**RE: STORMWATER MANAGEMENT ADVICE LETTER
LOT 117 ON SP316137 - EASTRIDGE STREET, STAPYLTON**

This advice letter has been prepared for submission to Gold Coast City Council as part of a Development Permit for Material Change of Use – Warehouse (with Ancillary Office) and specifically in response Council's Information Request dated 21 November 2022 for MCU/2022/525.

Figure 1: Typical Industrial Lot Catchment allocation per approved SBSWMP

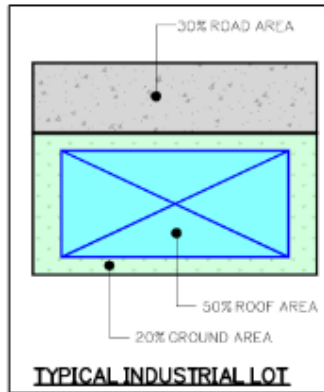
According to the approved Stormwater Management Plan (SWMP), stormwater quality and quantity estimations were made under the assumption the site comprises 80% impervious area and 20% pervious area. However, the proposed development appears to have an impervious area close to 100% of the site. Please clarify how the proposal meets the stormwater quantity/quality objectives within the approved SWMP. Provide a stormwater layout plan prepared by a qualified professional (RPEQ) for the entire site identifying all stormwater management measures.

The 20% ground catchment noted for a typical industrial lot within the approved SWMP for the wider subdivision (Vantage Yatala Stage 1 SBSWMP (Rev 5) dated January 2022) is further broken down within the modelling to be defined as 60% impervious and 40% pervious which translate to a previous ground assumption percentage of 8% of the total Lot 117 site area.
